BIDDERS BULLETIN

PROJECT: New Auto Service & Car Wash Building
Modern Muffler Tire Pro
1402 South Jeffers
North Platte Nebraska

BB-1

DATE ISSUED: April 23, 2012

DATE: April 23, 2012
DRAWING: A103.1

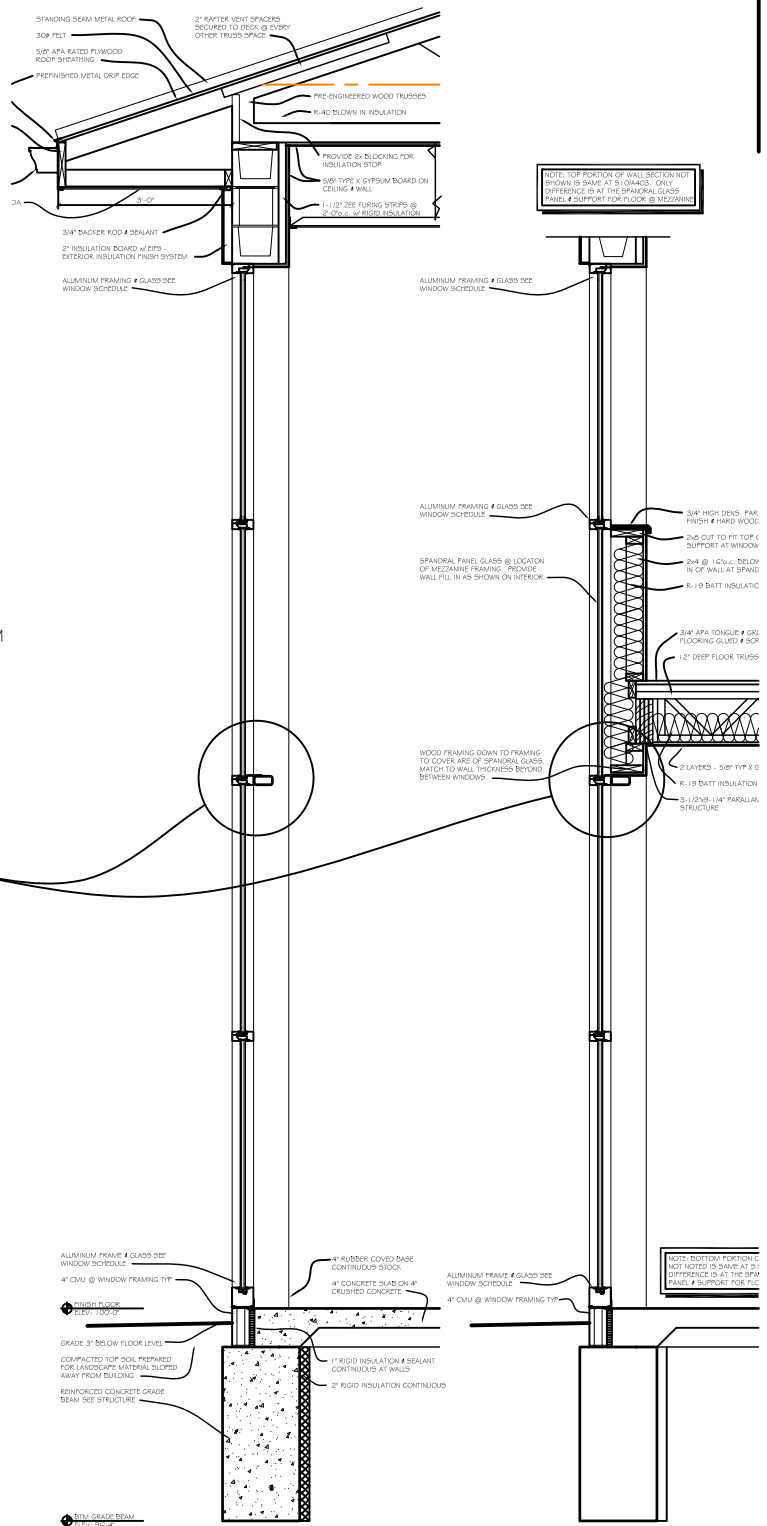
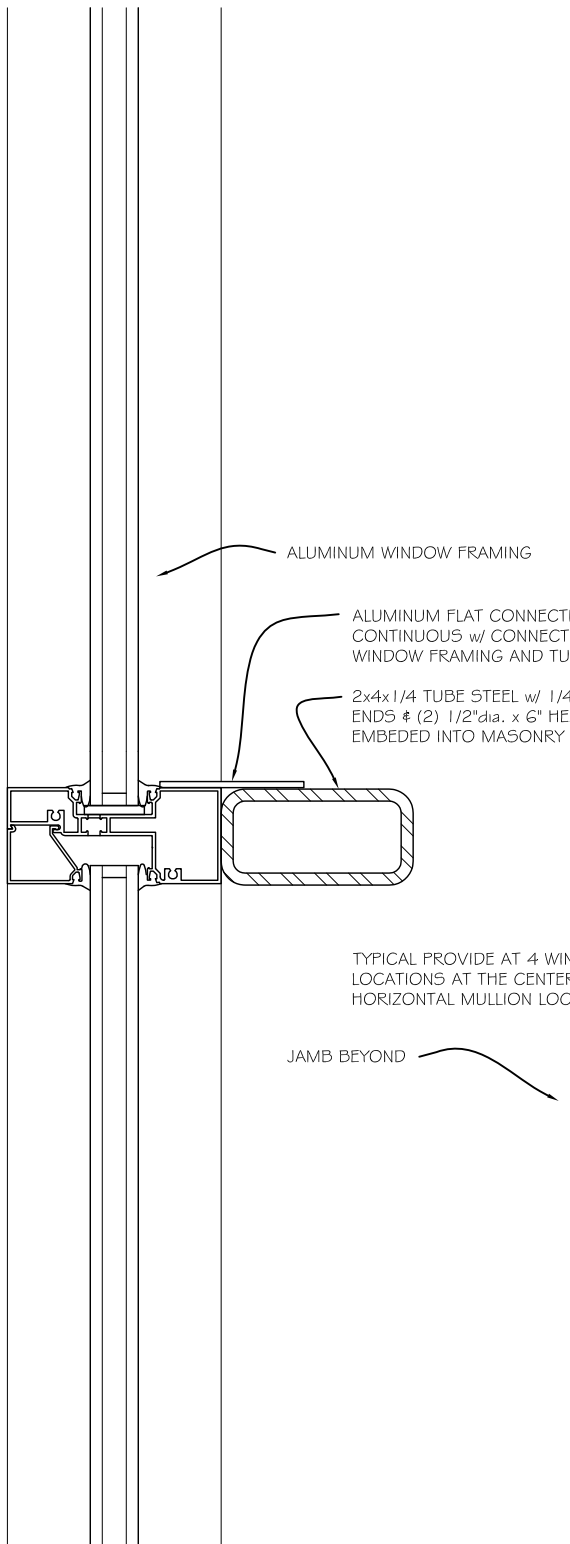
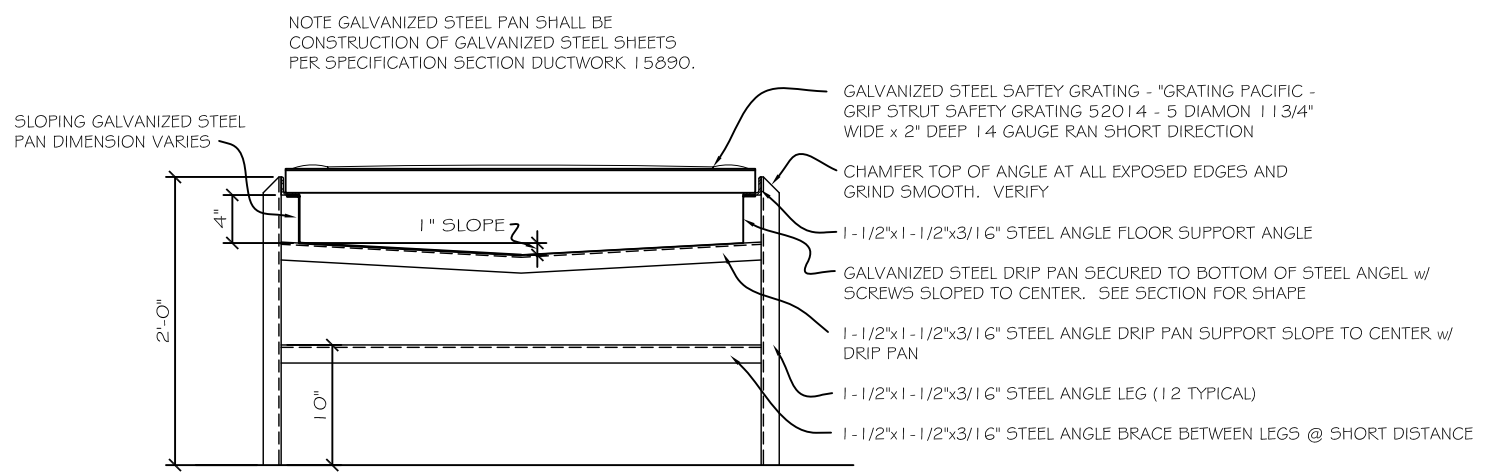
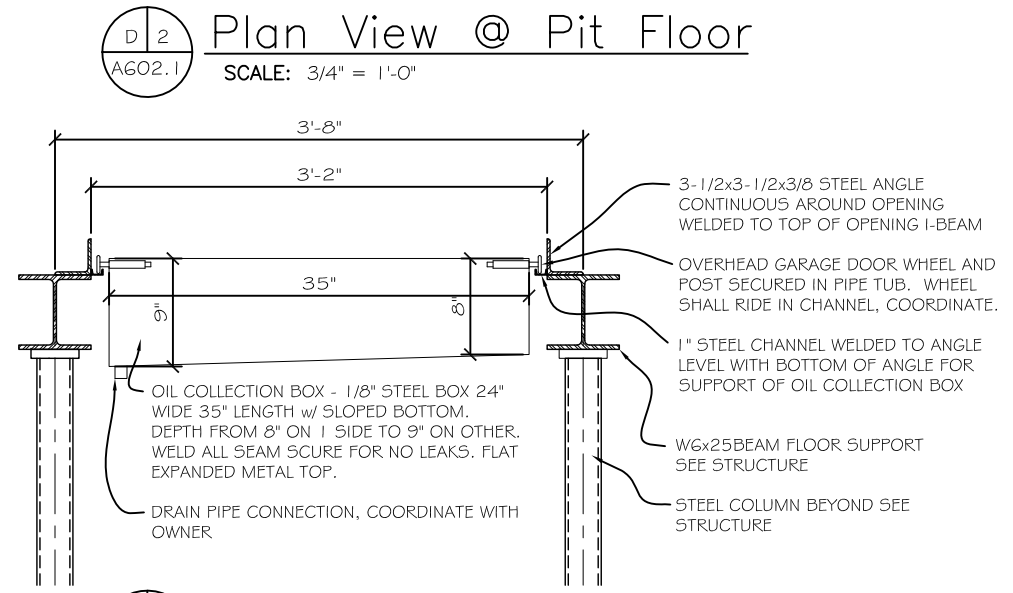
1. See attached sheet A103.1 for location of rated walls. Contractors shall take care to provide fire rated protection as noted for these wall continuous from floor to deck, provide all requirements for rating wall and all penetrations per codes.
2. Note ceiling tile change to Certainteed Cashmere as noted in BB1, Item #8.

D 1 Elevation Oil Pit Catwalk
 AGO2.2 SCALE: 3/4" = 1'-0"

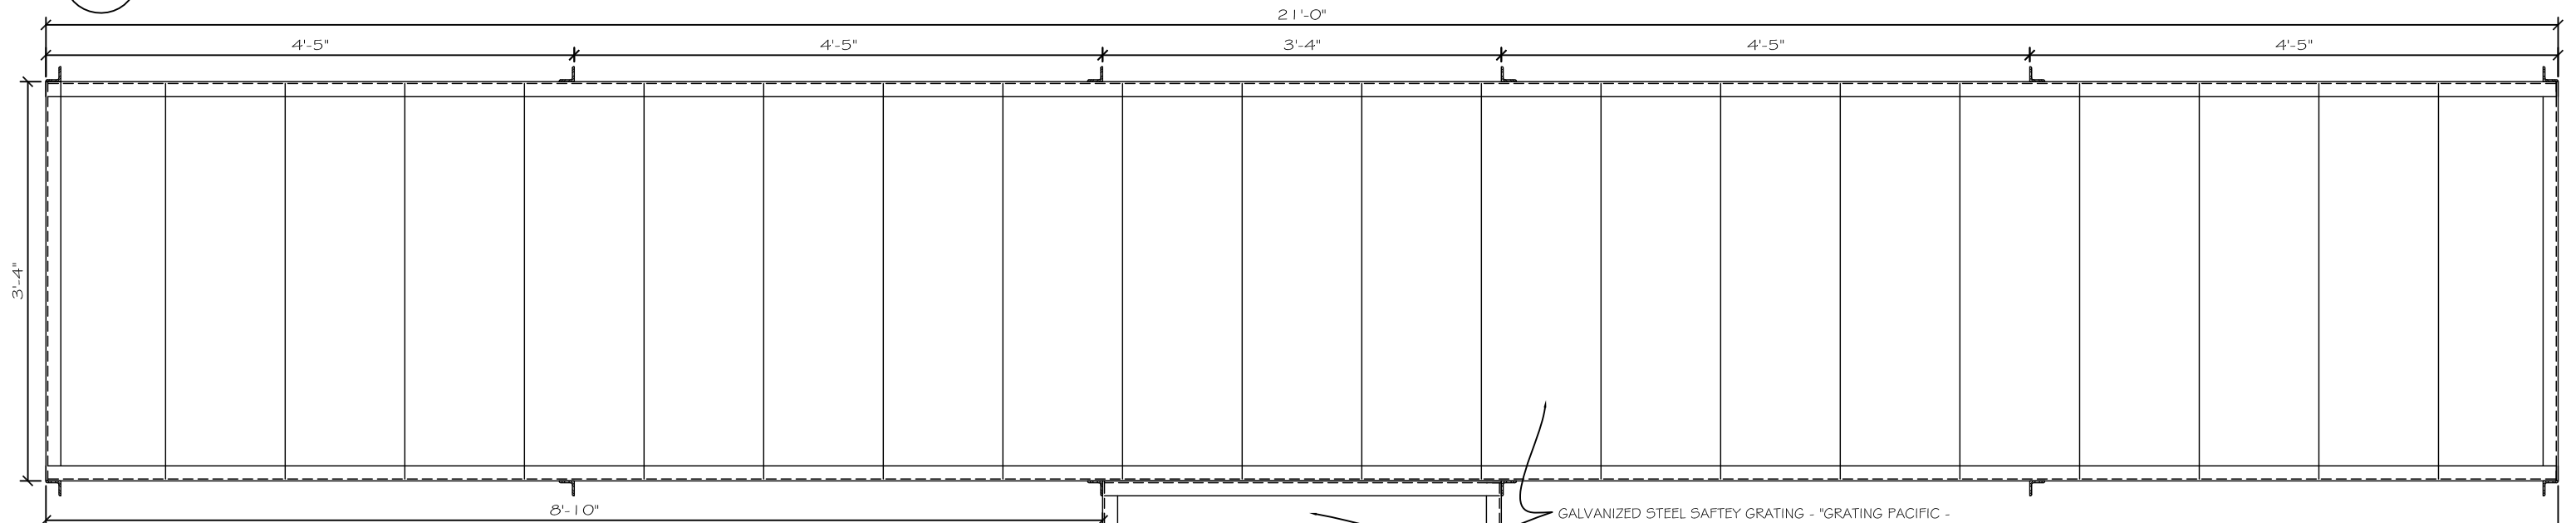
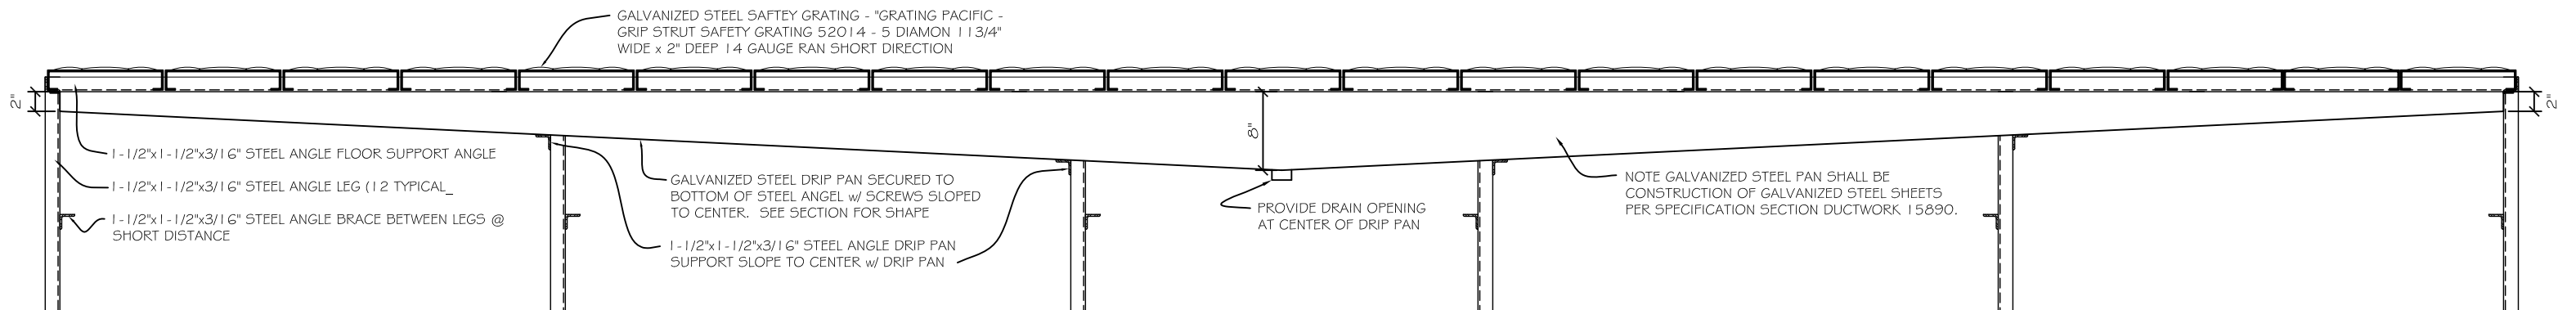
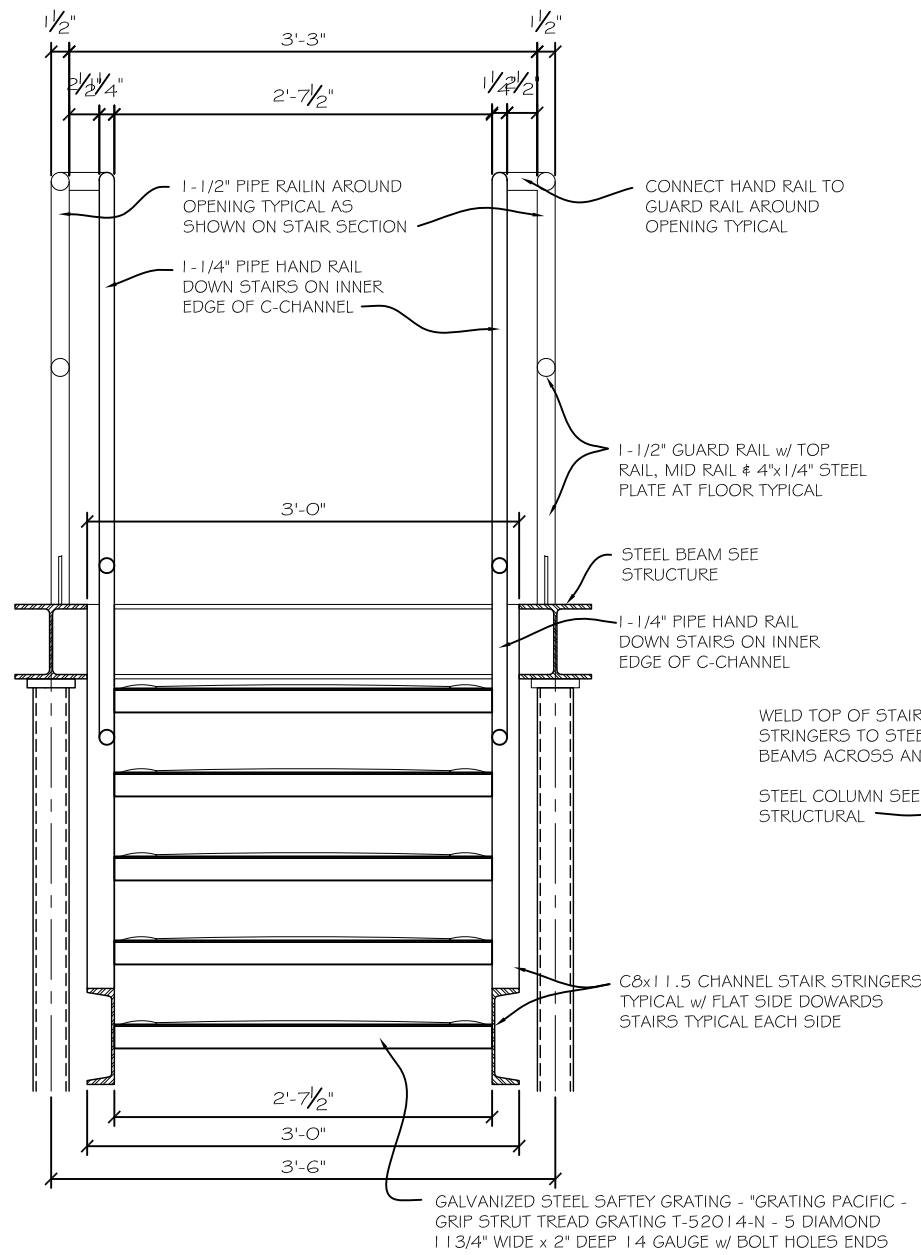
1. See attached details for Oil Pit Opening, Oil Pit Catwalk, Basement Stairs & 2nd Exit Detail on attached sheets A602.1, A602.2 & A602.3.

Title
 Basement Stair Section & Railing

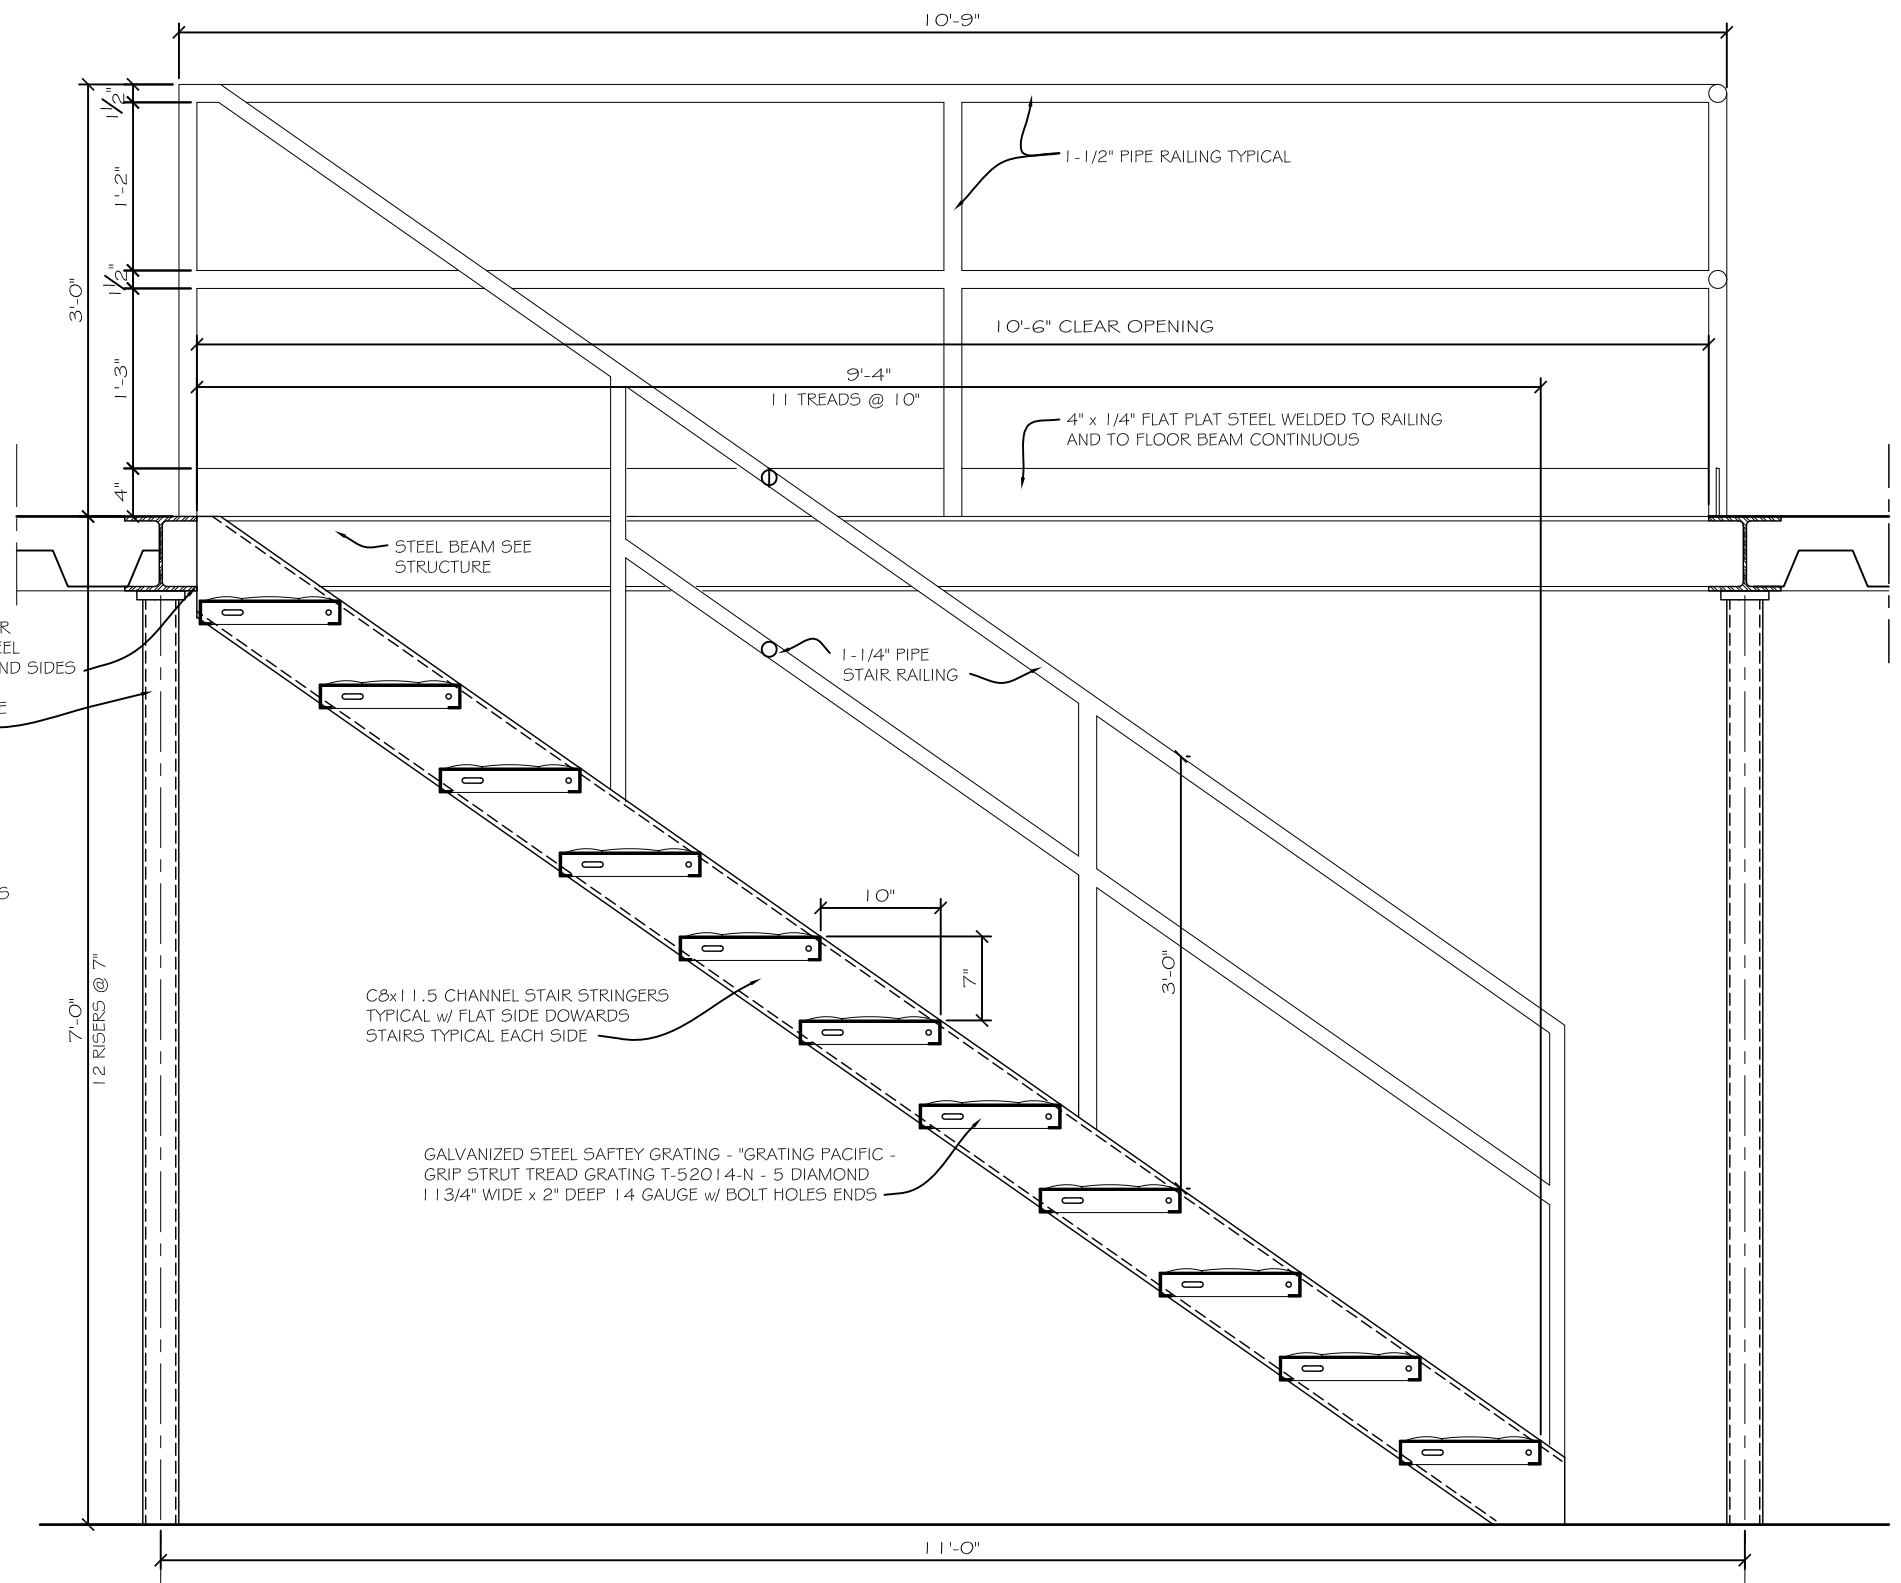
2. Provide ladder attached to wall out of basement at the exit location in the northwest corner similar to the ladder noted on sheet A301 for access to the mechanical mezzanine level. Provide ladder from basement floor level to 4'-0" above finish floor level. Provide 36" high 2 - pipe 1-1/2" pipe railing with 4" high by 1/4" base plate at floor railing on the south & east sides of opening and a chain guard on the north side of opening. Provide posts at corners & wall typical. Weld to floor framing, coordinate.

PRECAST CONCRETE OIL/WATER SEPERATOR

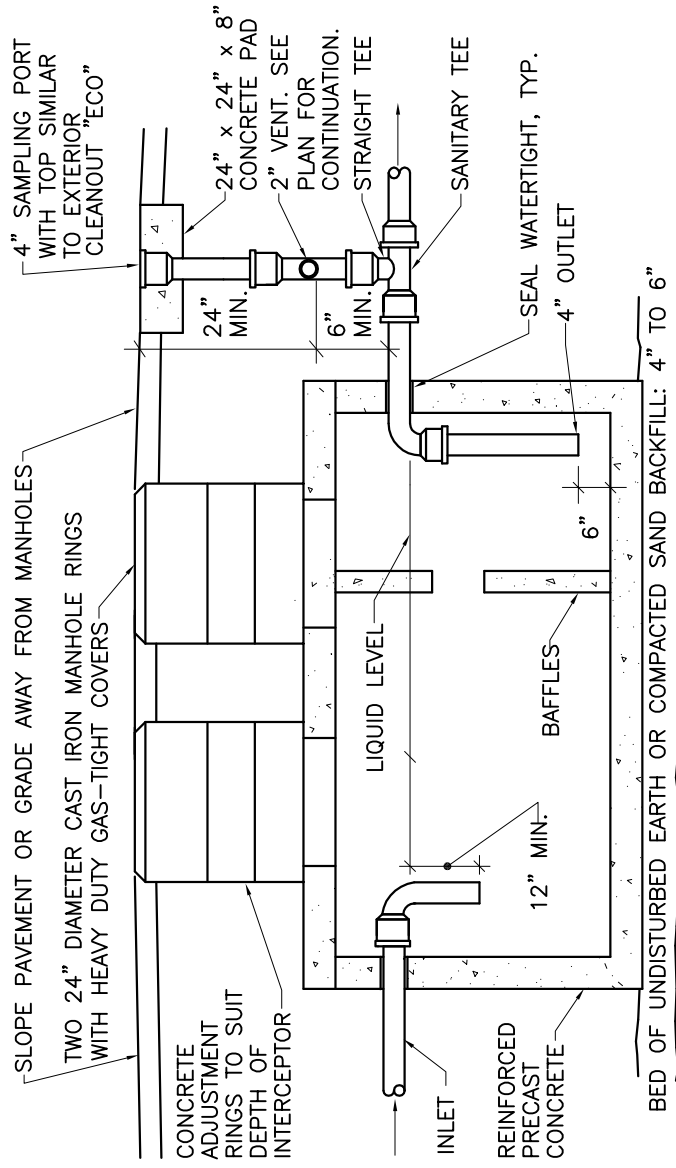
Item #1: Oil Water Separator – See detail on attached drawing for Oil Water Separators at Service Station Building and Car Wash Building. See Sheet P200 for location at Car Wash and see Civil Utility Plan for location at Service Station Building. Coordinate with General Contractor. Refer to plumbing drawings for inlet and outlet pipe sizes.
